MFD NON-COMPLIANCE REPORT # 27937-49

PART NAME: **ALIGNMENT PIN 1**
PF/SA NO.: **PF-380-545-29**
WORK ORDER NO.: **27937-49**
VENDOR **MFD**

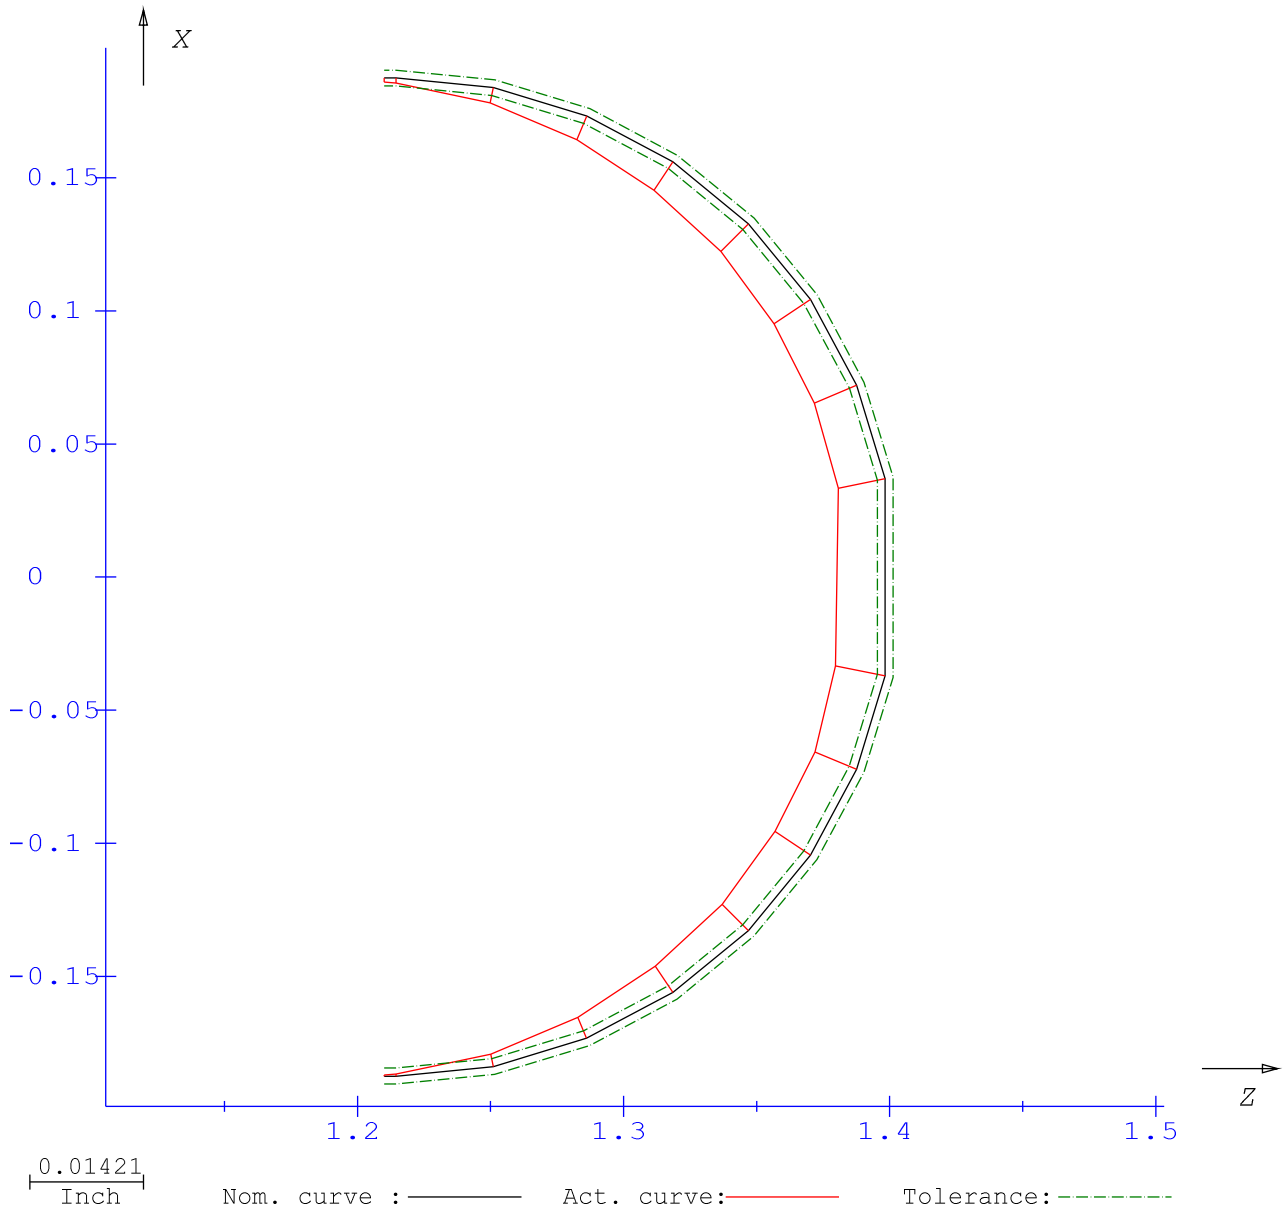
1.  is out of profile. The profile is undersized from C-D. View Profile Plot on next page.
